MONTGOMERY INDUSTRIAL PARK

SITE PLAN AMENDMENT 81990069C AND 81994026C

Request to construct a building addition and canopy enclosure, increasing building square footage by 5,525 square feet on Lot 32; construct a building addition increasing building square footage on Lot 33 by 3,320 square feet; and create a new inter-lot connection between Lot 32 and Lot 33.

No. 81990069C & 81994026C Completed: 06-09-2022 MCPB Item No. 06-23-2022 Montgomery County Planning Board 2425 Reedie Drive Floor 14 Wheaton, MD 20902

FIRE APPARATUS ACCESS PLAN

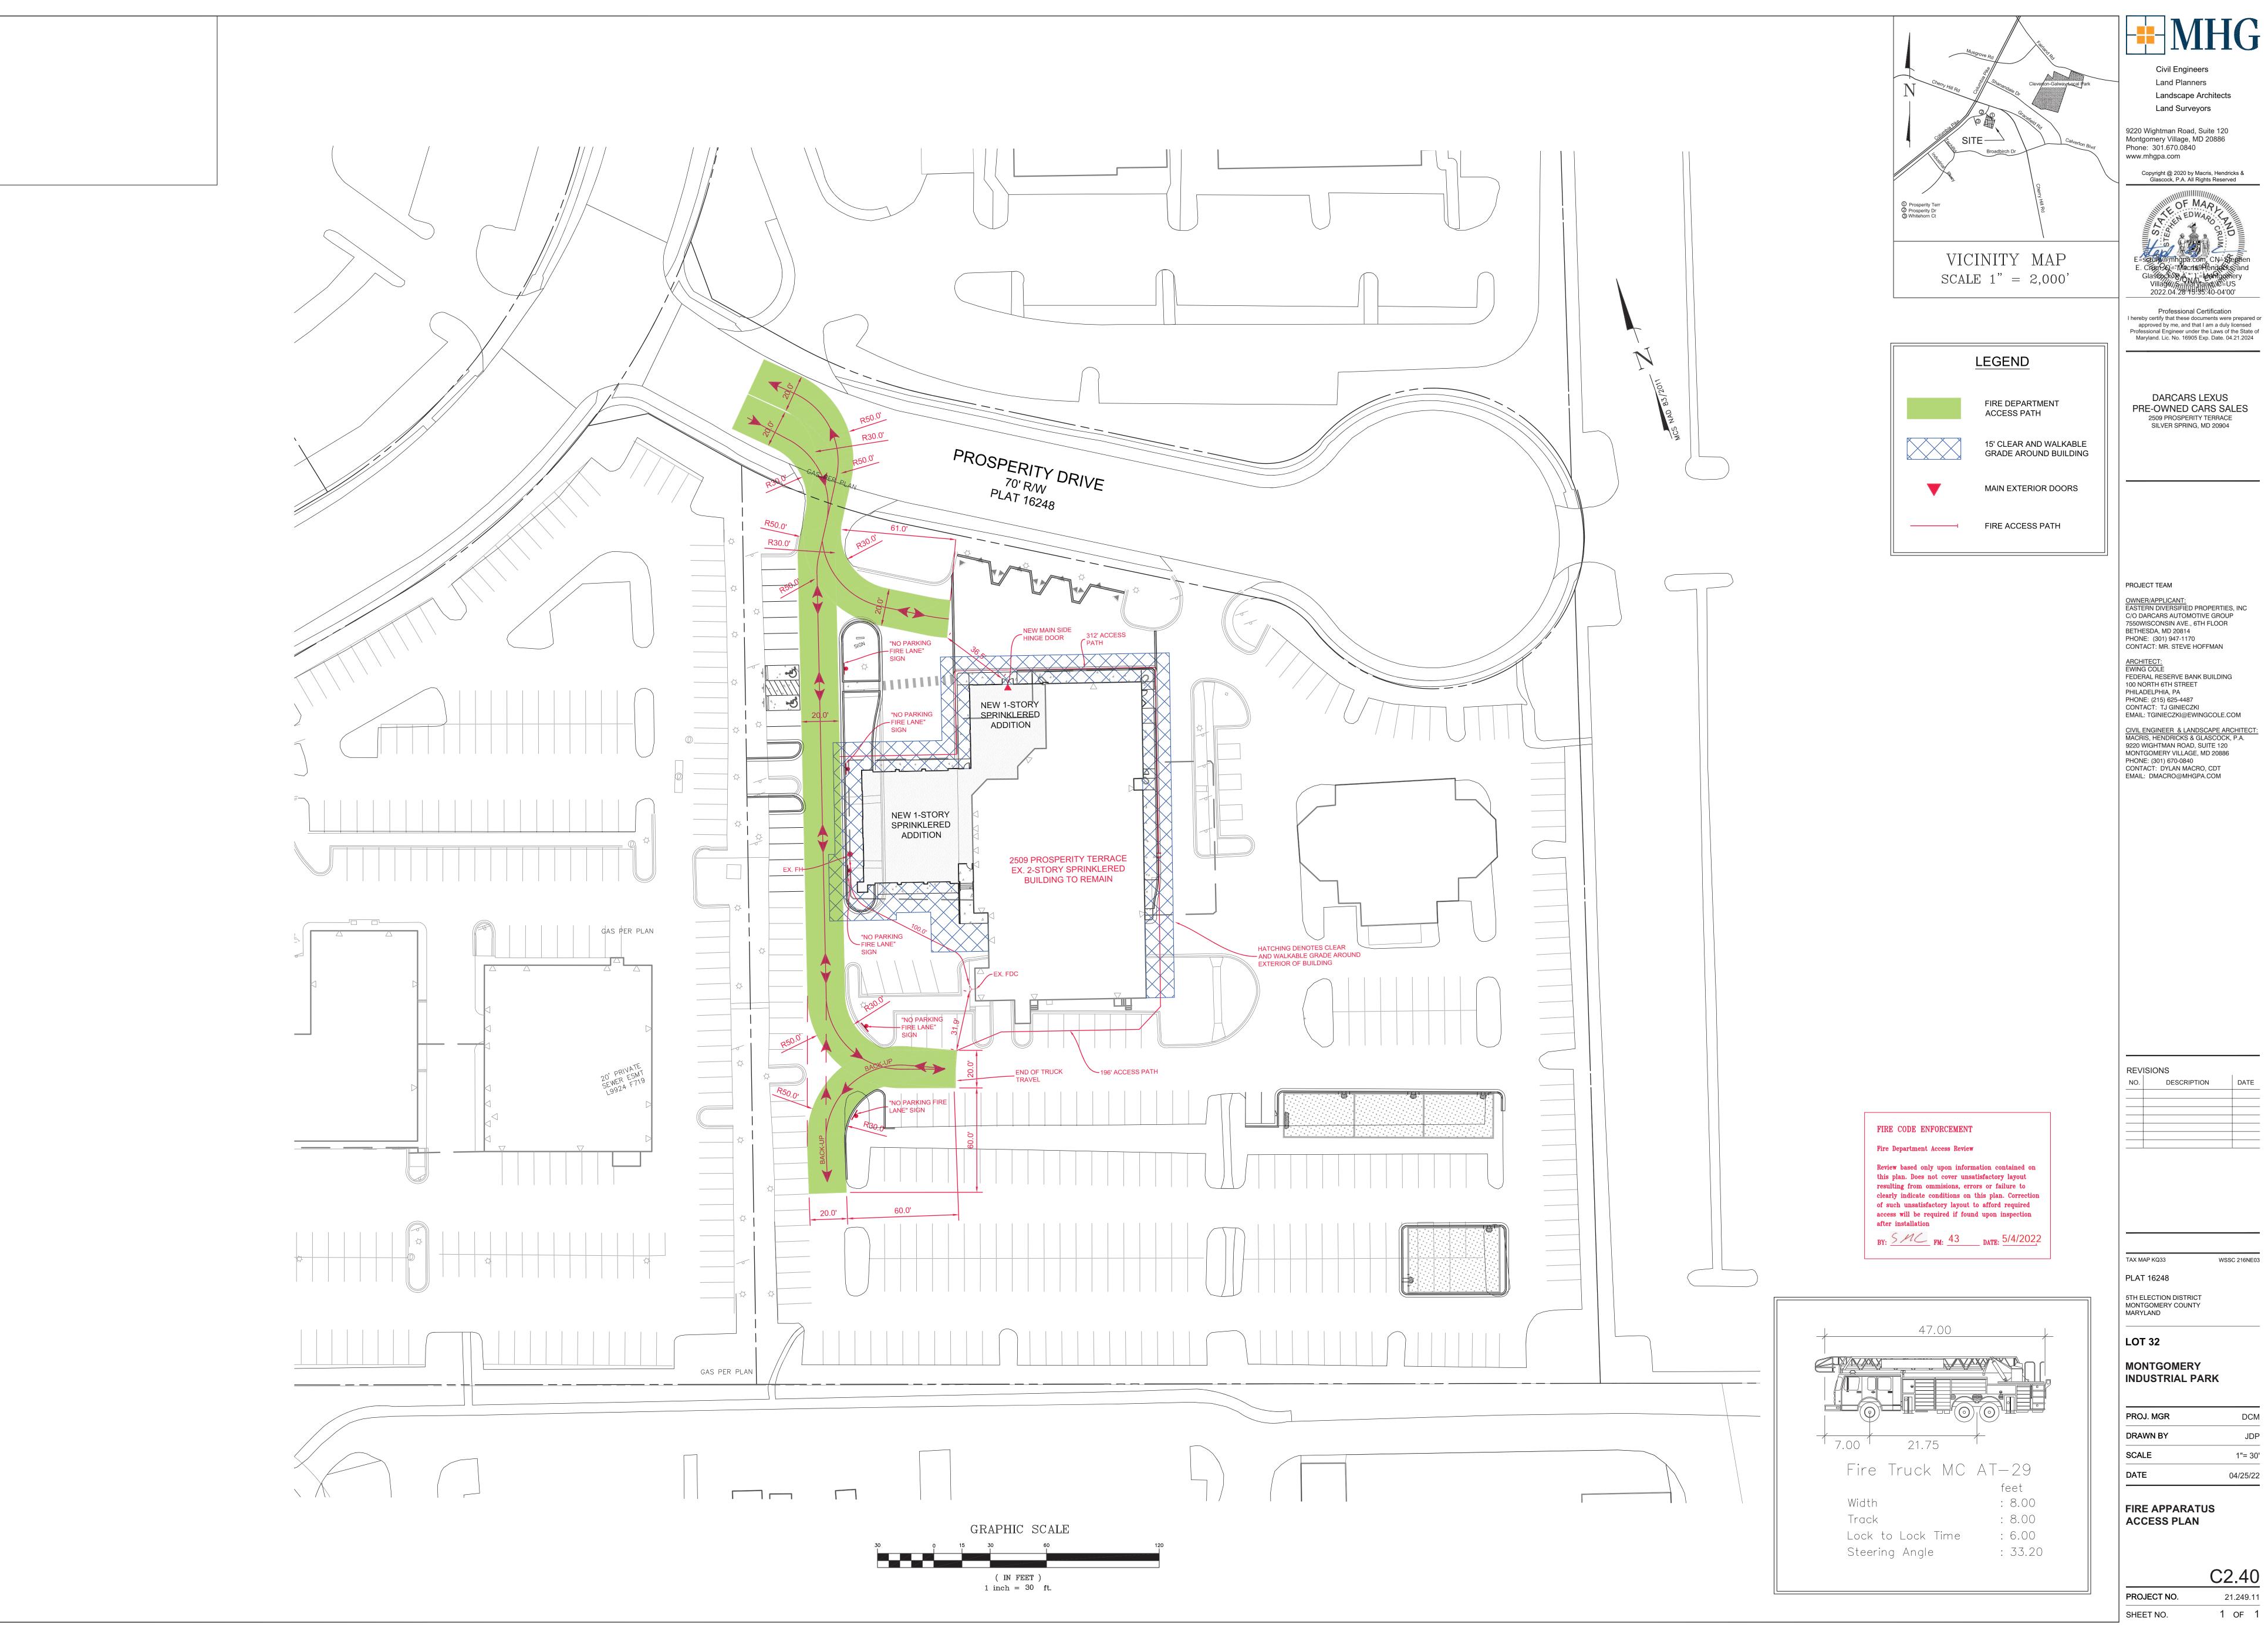
The existing Fire Department Connection (FDC) is located on the southeast corner of the sales showroom and service center building. The existing Fire Department Connection and automatic sprinkler system will remain unchanged with the planned improvements. The existing FDC is within 32-feet of the Fire Department Apparatus Access Path and within 100-feet of the nearest existing fire hydrant, which is to remain. The distance from the existing FDC to the existing main side hinge door is currently 265-feet and is an existing non-compliant condition. Construction of the new addition will increase the distance from the existing FDC to the new main side hinge by approximately 30-feet, to 295-feet and will remain and non-compliant condition; however, as noted above, the fire department apparatus access path will now be 30-feet closer to the new main side hinge door than the existing main side hinge door is currently from the fire department apparatus access path.

In summary, the proposed improvements will not adversely affect the Fire Department's Access to the existing fire department connection, existing fire hydrant or new main side hinge door. Given the items outlined above, we request your approval of the Fire Department Apparatus Access Plan and associated Statement or Performance Based Design for the above referenced project.

Review based only upon information contained on this plan. Does not cover unsatisfactory layout resulting from ommisions, errors or failure to clearly indicate conditions on this plan. Correction of such unsatisfactory layout to afford required access will be required if found upon inspection after installation

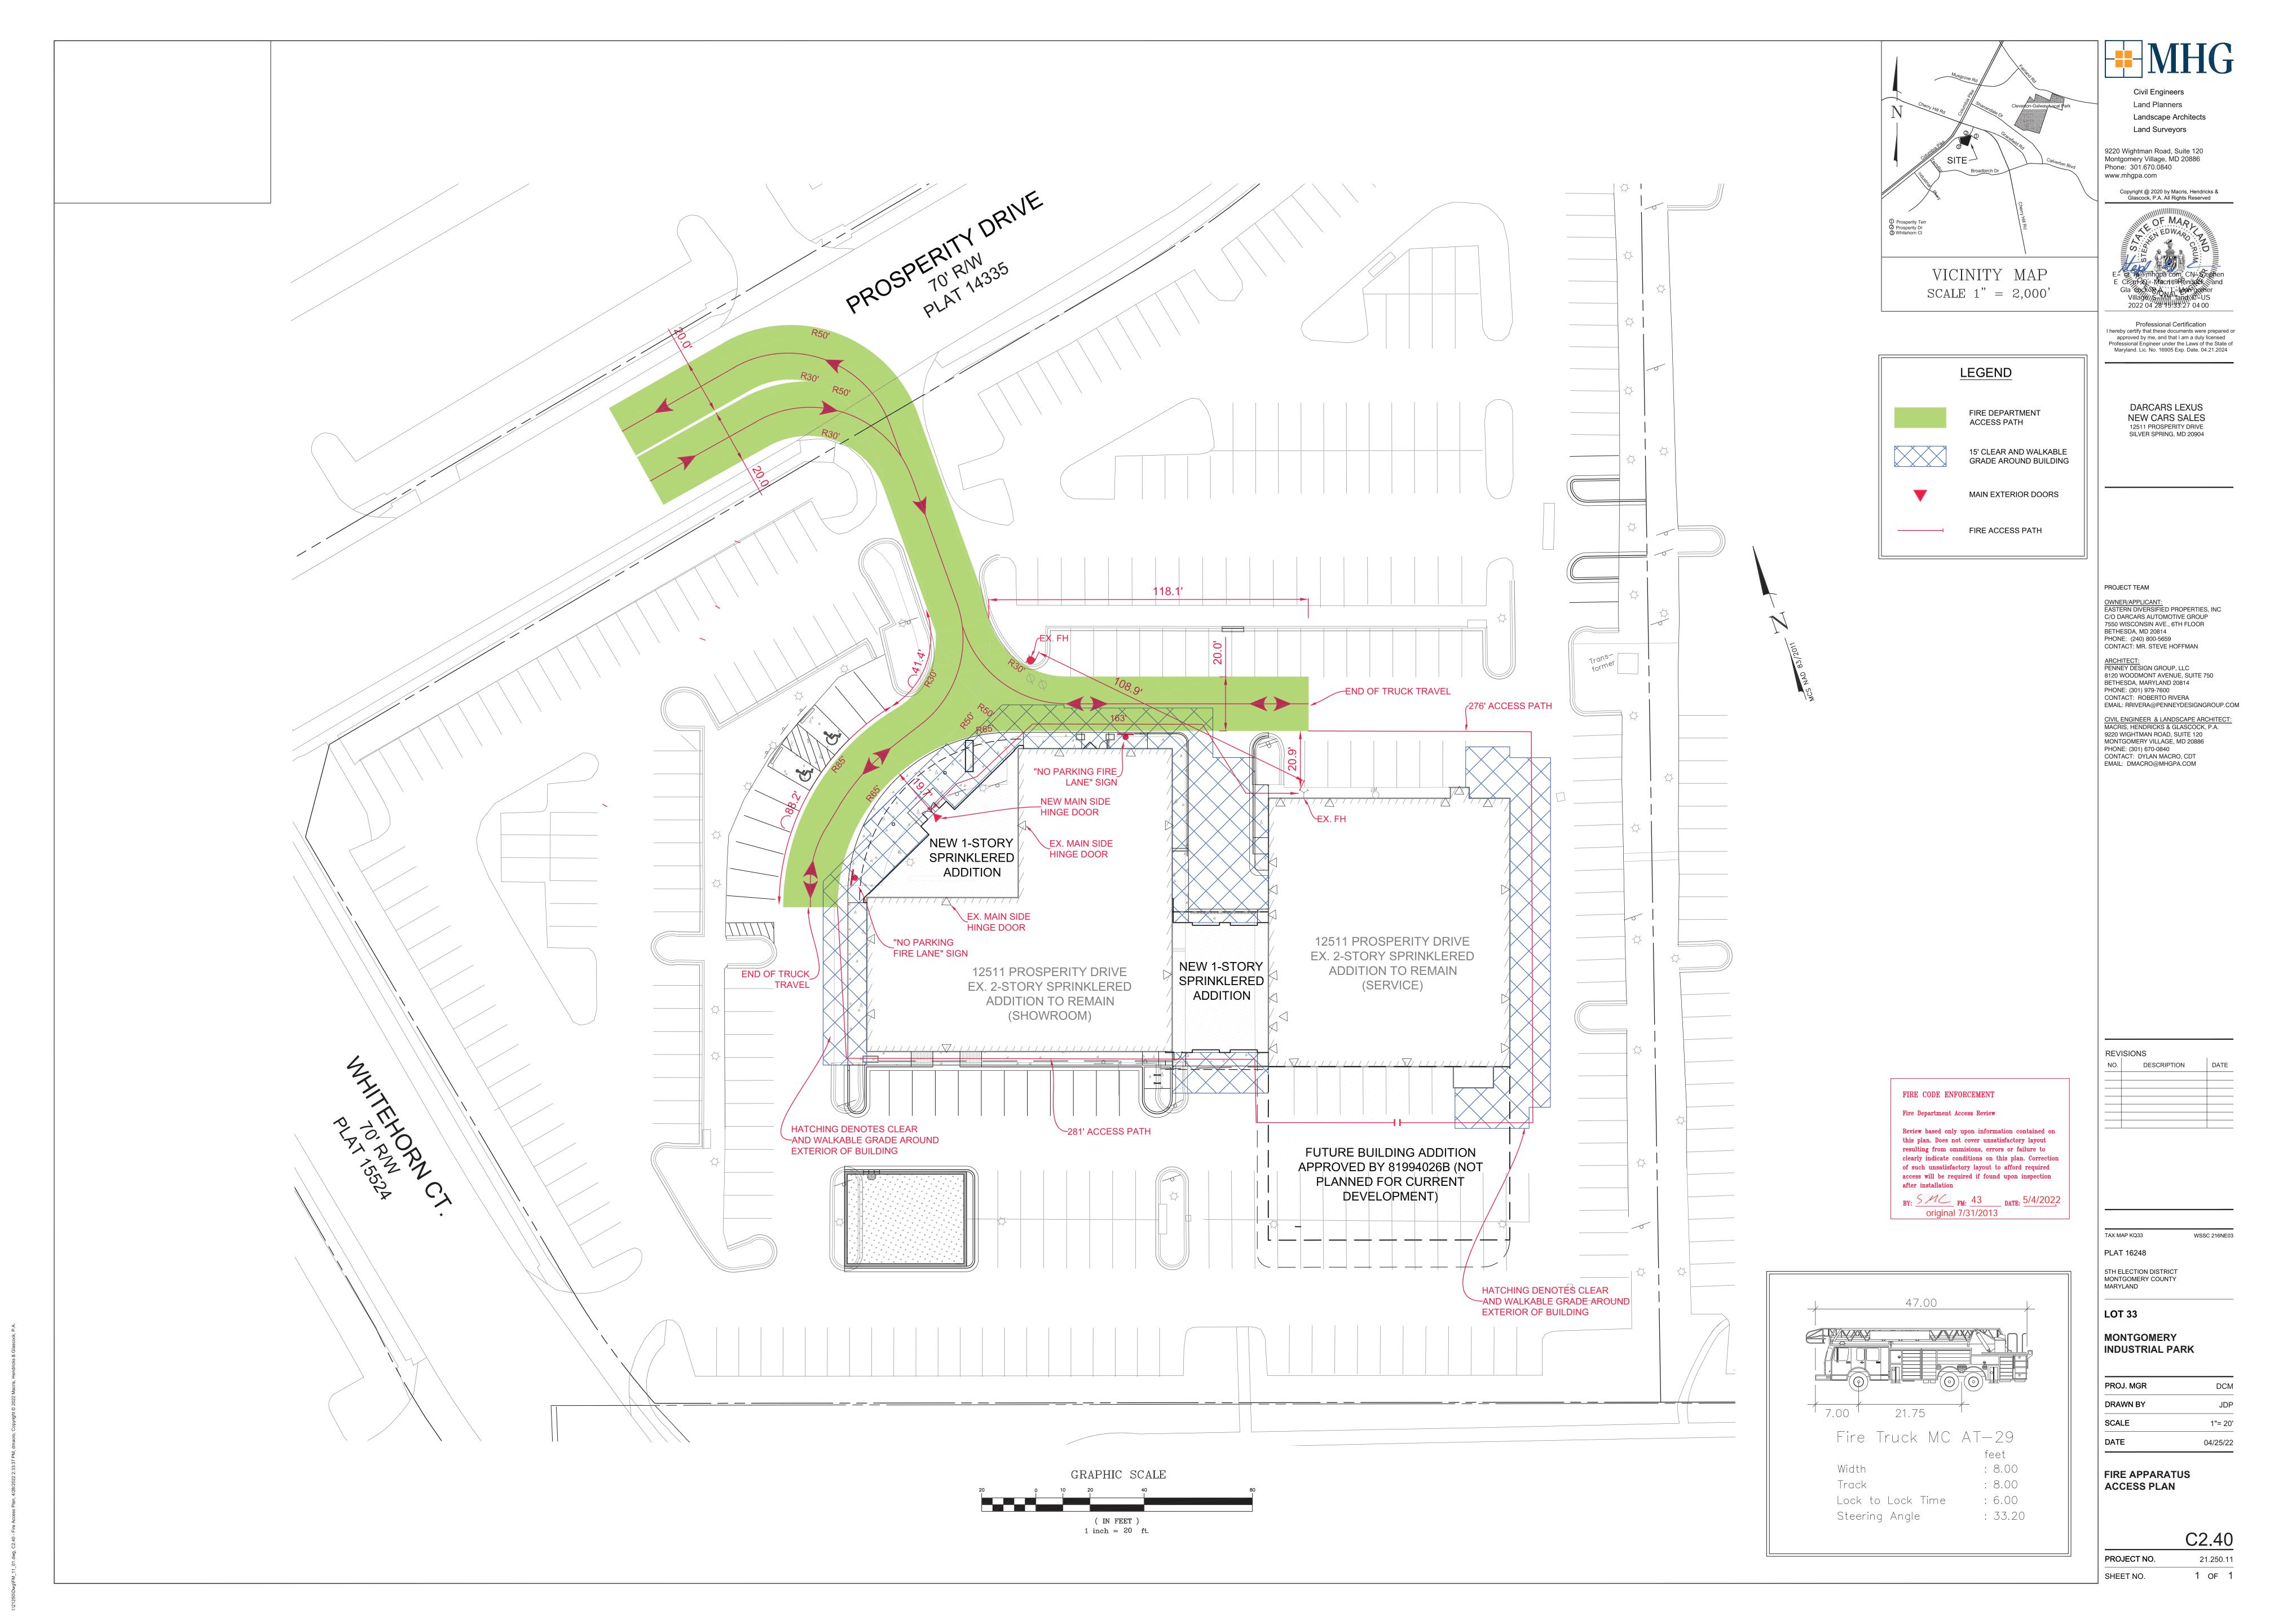
The existing Fire Department Connection (FDC) is located on the northwest corner of the existing service center building and is to remain. The existing automatic sprinkler system serves both buildings under existing conditions and will remain unchanged with the planned improvements. The existing FDC is within 30-feet of the Fire Department Apparatus Access Path; however, it is located 109-feet from the nearest existing fire hydrant, which is an existing non-compliant condition, and 163-feet from the new main side hinge door. The distance from the FDC to the existing main side hinge door is 156-feet, which is approximately 7-feet closer to the existing main side hinge door than the new main side hinge door, however, as noted above, the new main side hinge door will be approximately 15-feet closer to the Fire Department Apparatus Access Path. The distance from the existing FDC to the existing main side hinge door and fire hydrant are existing non-compliant conditions.

In summary, the proposed improvements will not adversely affect the Fire Department's Access to the existing fire department connection, existing fire hydrant or new main side hinge door. Given the items outlined above, we request your approval of the Fire Department Apparatus Access Plan and associated Statement or Performance Based Design for the above referenced project.

Review based only upon information contained on this plan. Does not cover unsatisfactory layout resulting from ommisions, errors or failure to clearly indicate conditions on this plan. Correction of such unsatisfactory layout to afford required access will be required if found upon inspection after installation
